TECHNICAL BULLETIN
Sorted by Bulletin Number
September 28, 1988

TANDY COMPUTER PRODUCTS

BULLETIN NO: 20000:1

PRODUCT: 26-5140 High Resolution Graphics PCB

Figure 1

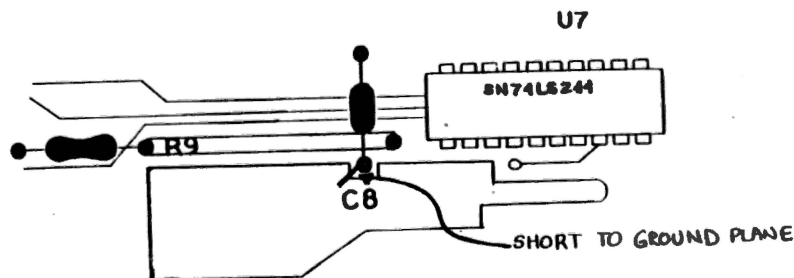
DISCUSSION/PROCEDURE: Some early production hard drive controller boards were missing a resistor (R28), had two wrong valued capacitors installed (C5 and C6), and had one capacitor which was not grounded properly (C8). All Tandy 2000 hard drive controller boards should be checked for the following:

1. Make sure R28 has a 470 ohm 1/4 watt 5% resistor installed in that silk screen position.
2. Check C5 and C6 to insure 100 pfd capacitors are installed and not 150 pfd capacitors.
3. Check C8 to insure that the open pin is attached to the ground plane nearest it (Refer to Figure 1).

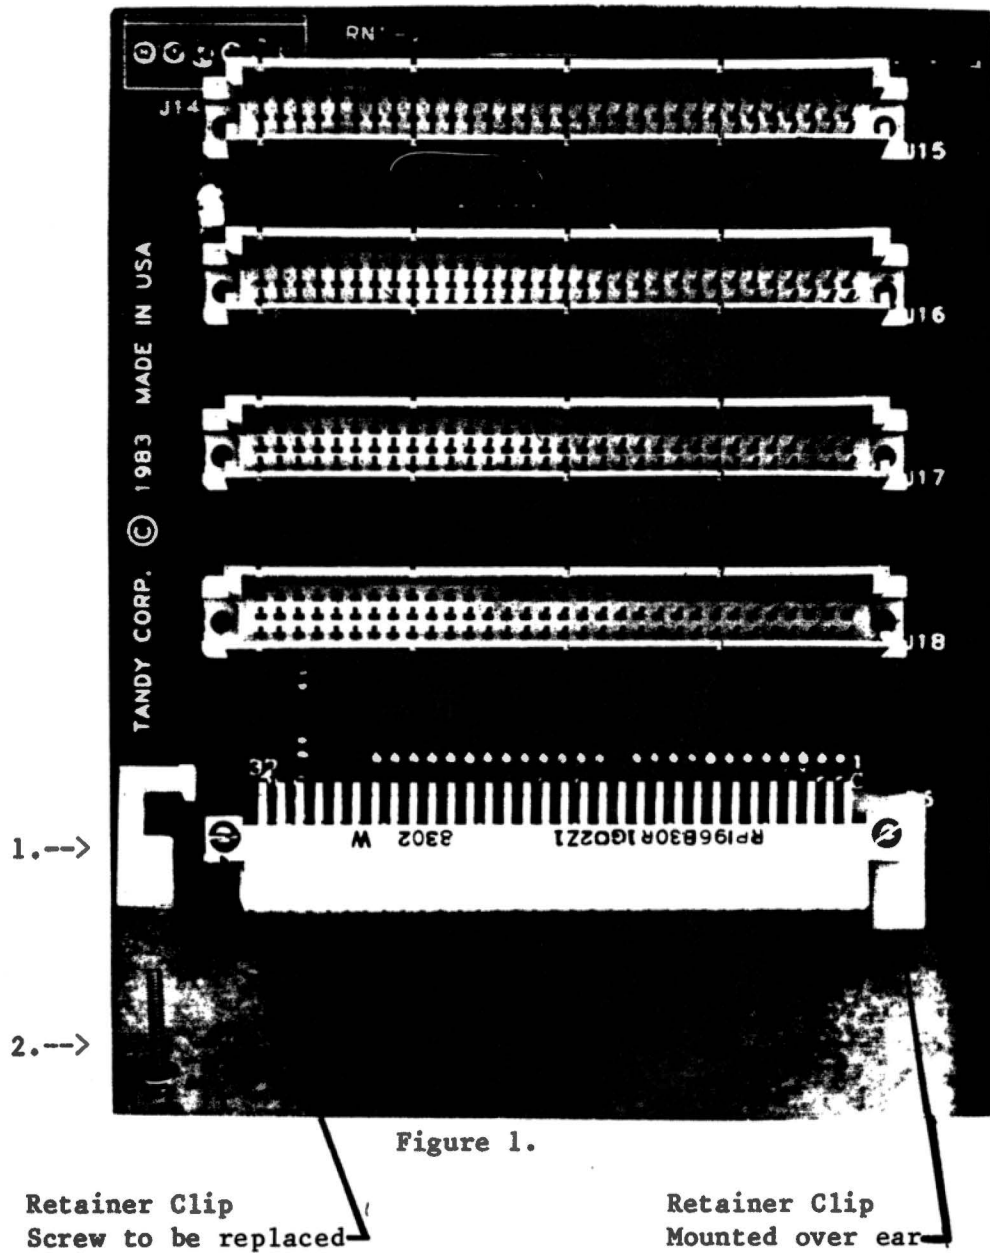
3. (Refer to figure 1.) Remove screws and nuts holding (P6)(96-pin connector) to the motherboard. Replace the original screws with the #4 x 1/4" screws and the #6 lock washers. These are used to hold the retainer clips tightly in place.

4. (Refer to figure 1.) Place the retainer clips over the screw ears of the connector (P6) behind #6 lock washer if used.
5. Reattach the main logic board to the pan. Reinstall the mother board and insert the two screws into standoff's from bottom side. Thread the two screws into the retainer clips, pulling the two boards together for a tight fit. WARNING: Do not over tighten the screws or you will strip out the retainers.
6. Reassemble unit and test for proper operation.

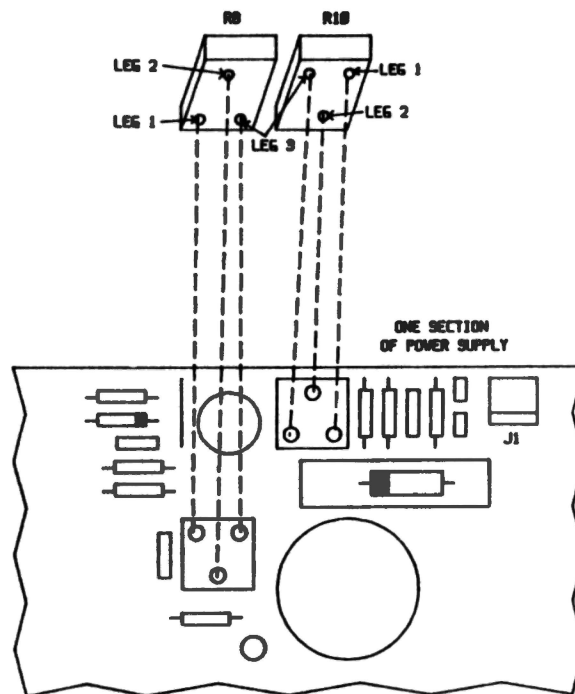
1. Gain access to the power supply's potentiometers by removing the top case of the Tandy 2000 and the top metal shield of the power supply.
2. With **ALL** of the customers expansion boards installed, turn the unit on and measure the +5 and +12 volt supplies and adjust them if necessary.

+5 volt range = 5.00 to 5.25

+12 volt range = 11.75 to 12.25

+12 volts can be measured at J2 pins 1 or 2 and adjusted by R8.

3. Turn the unit off and remove the power supply PCB.
4. Referring to the figure below remove R10 (+5 volt), observing the leg orientation. With an OHM meter measure the resistance between Leg 1 and Leg 2. This is the first fixed resistor value. Measure the resistance between Leg 3 and Leg 2. This is the second fixed resistor value.

Figure 1

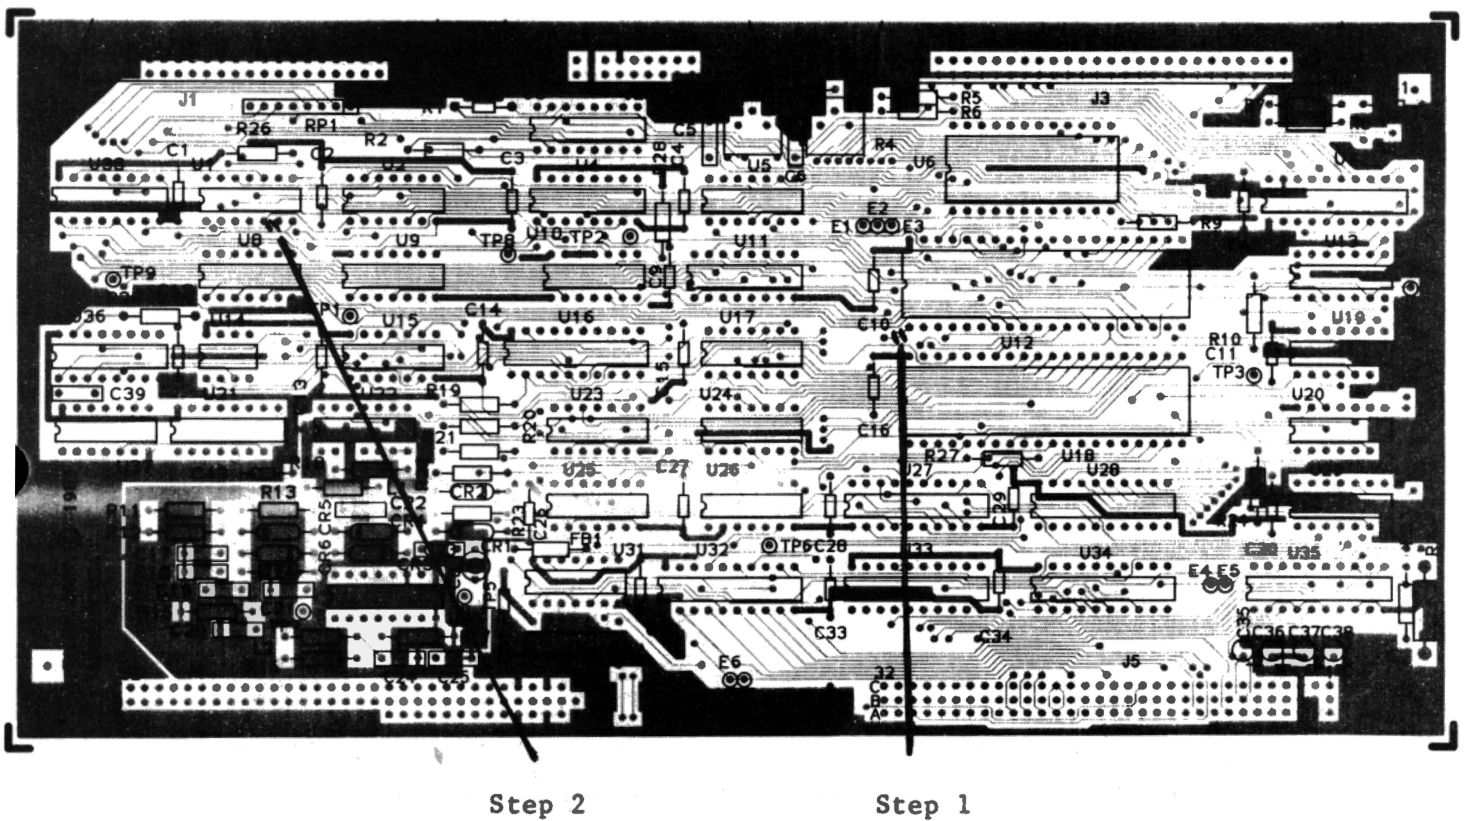
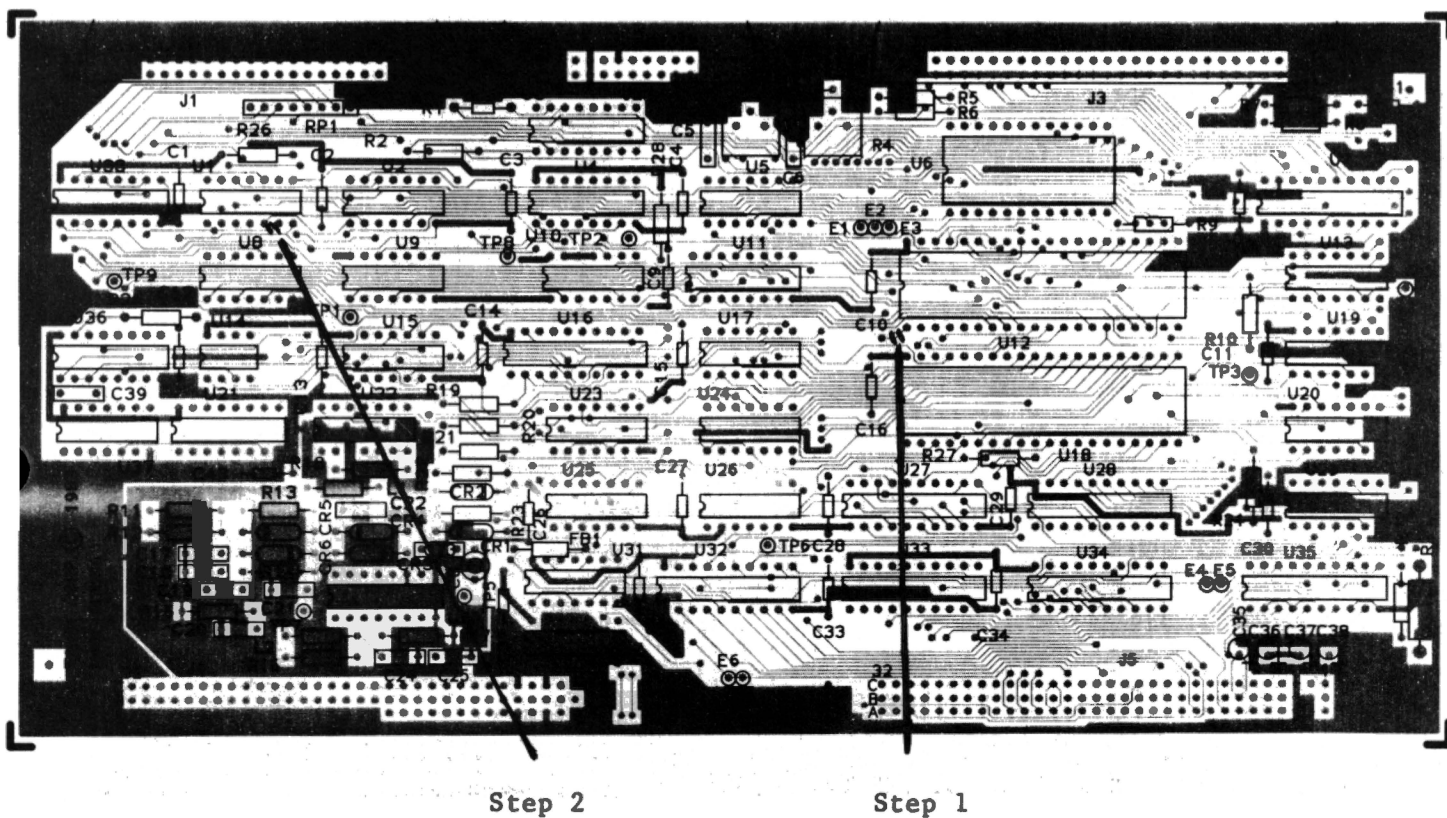
Original Modification:

ON THE COMPONENT SIDE REFER TO FIGURE 1:

Figure 2

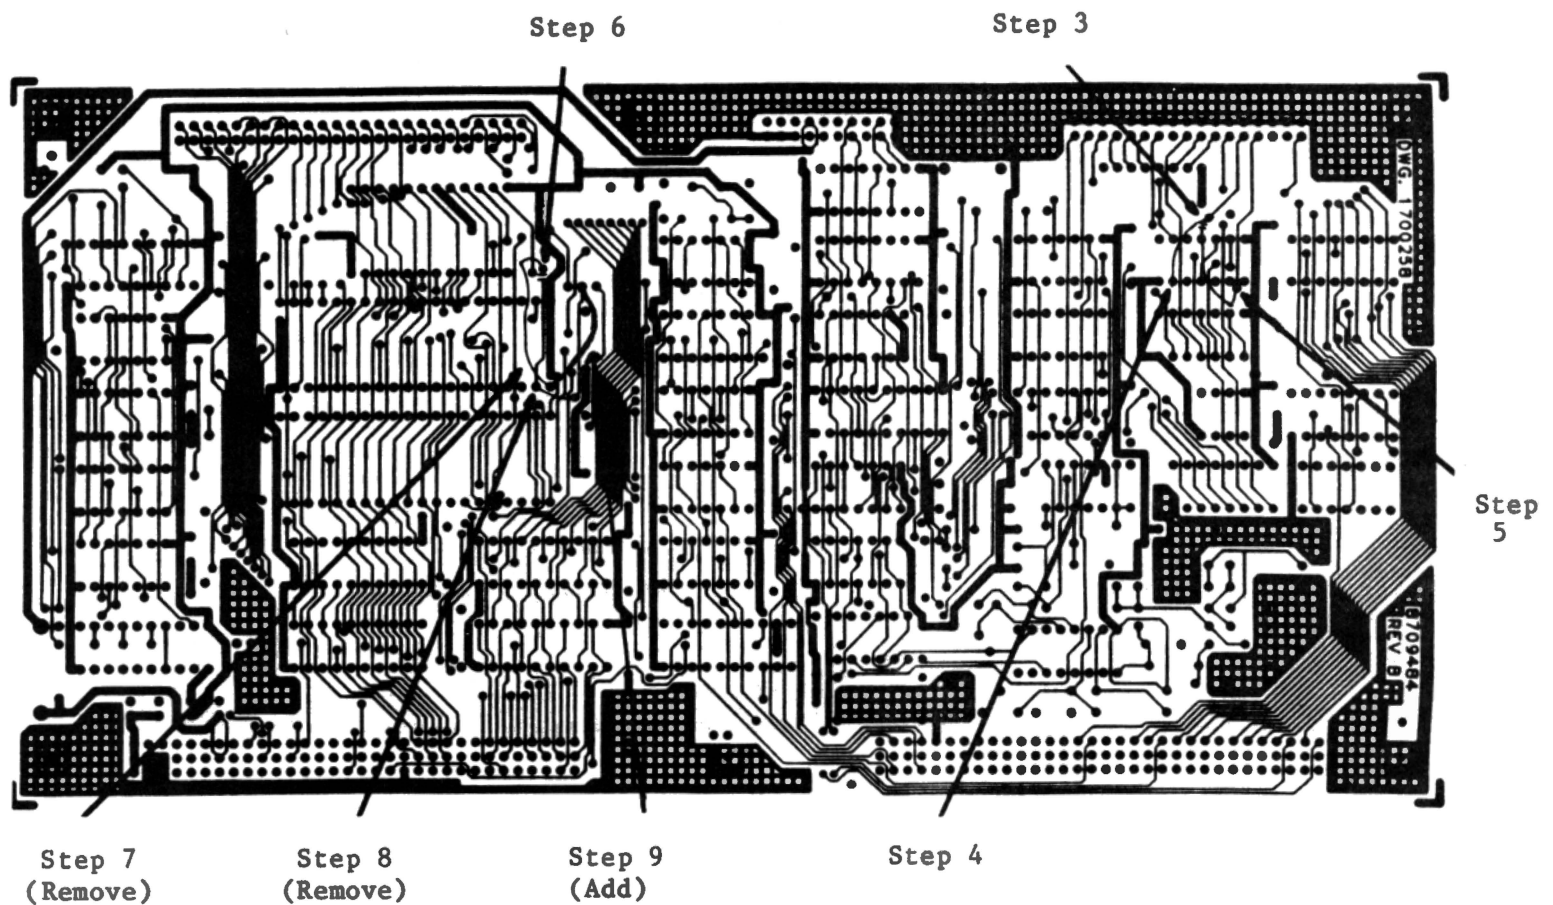
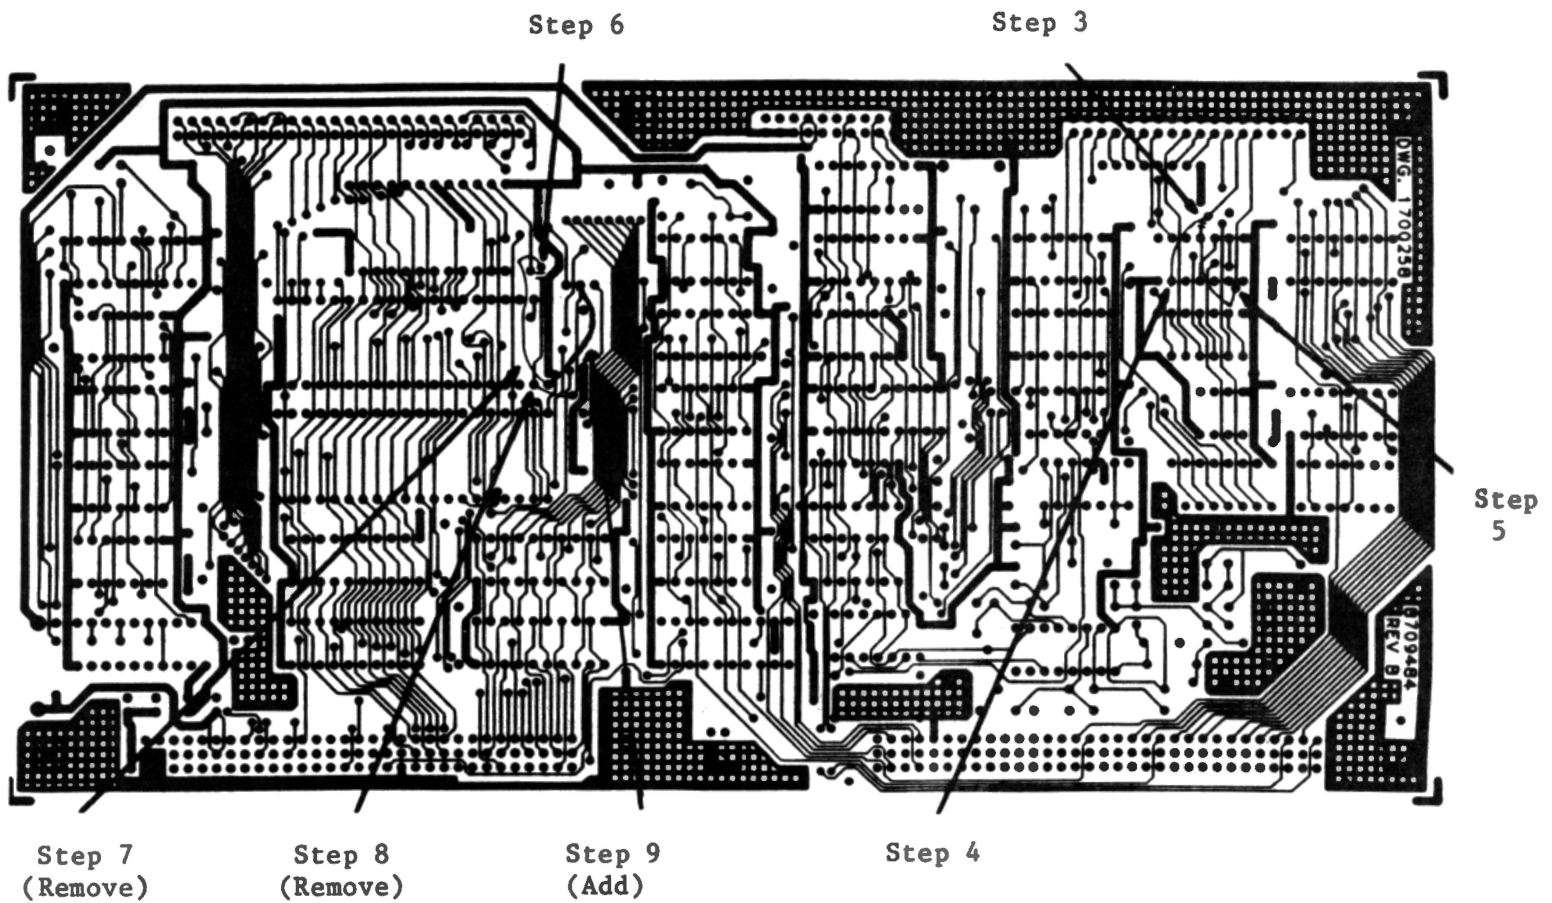
ON THE SOLDER SIDE REFER TO FIGURE 2:

ON THE SOLDER SIDE REFER TO FIGURE 2:

1. Remove the jumper from U12 pin 1 to the feedthrough. Refer to Step 7 of the original procedure and drawing.
2. Remove the jumper from U12 pin 2 to the feedthrough. Refer to Step 8 of the original procedure and drawing.
3. Jumper U12 pin 1 to the E2 staking pin. This remakes the trace cut in Step 1 of the original procedure. Refer to Step 9 of the drawing.
4. Refer to the enhanced modification on Page 1 of 6 and perform steps 5, 6, and 8.

Figure 3

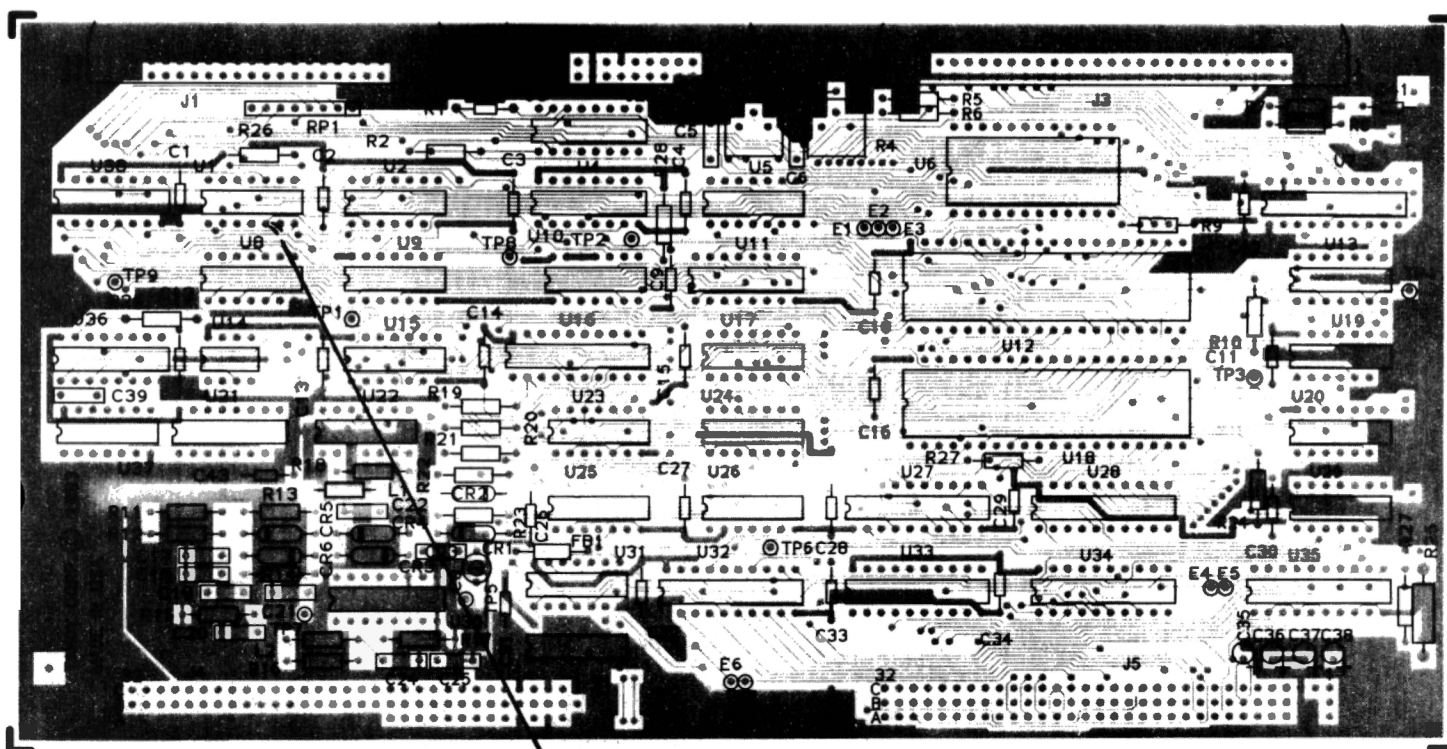
Enhanced Modification:

ON THE COMPONENT SIDE REFER TO FIGURE 3:

Figure 4

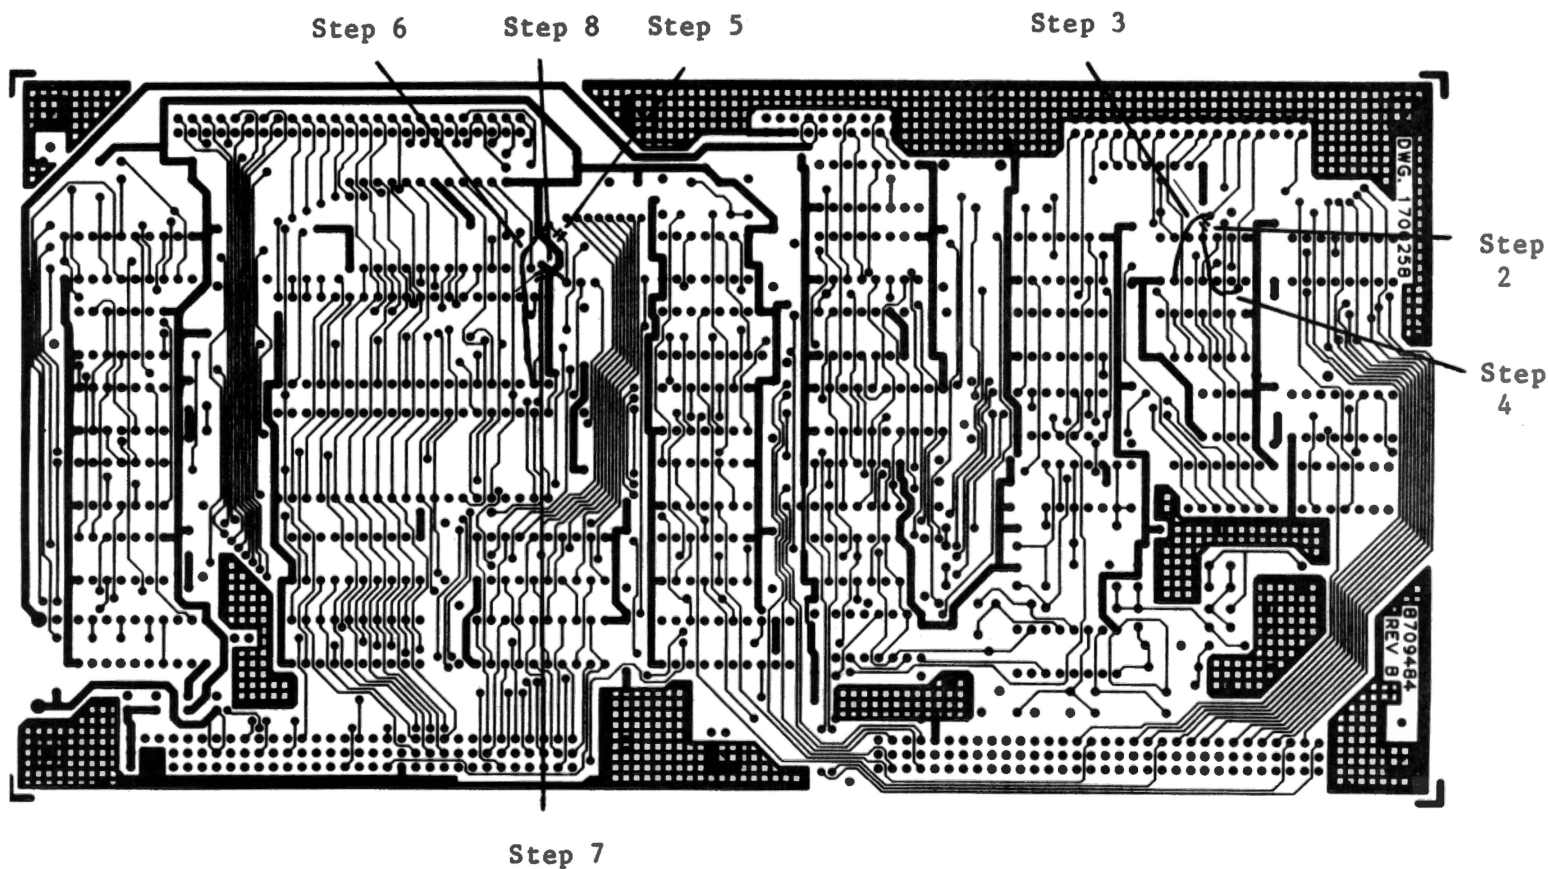
ON THE SOLDER SIDE REFER TO FIGURE 4:
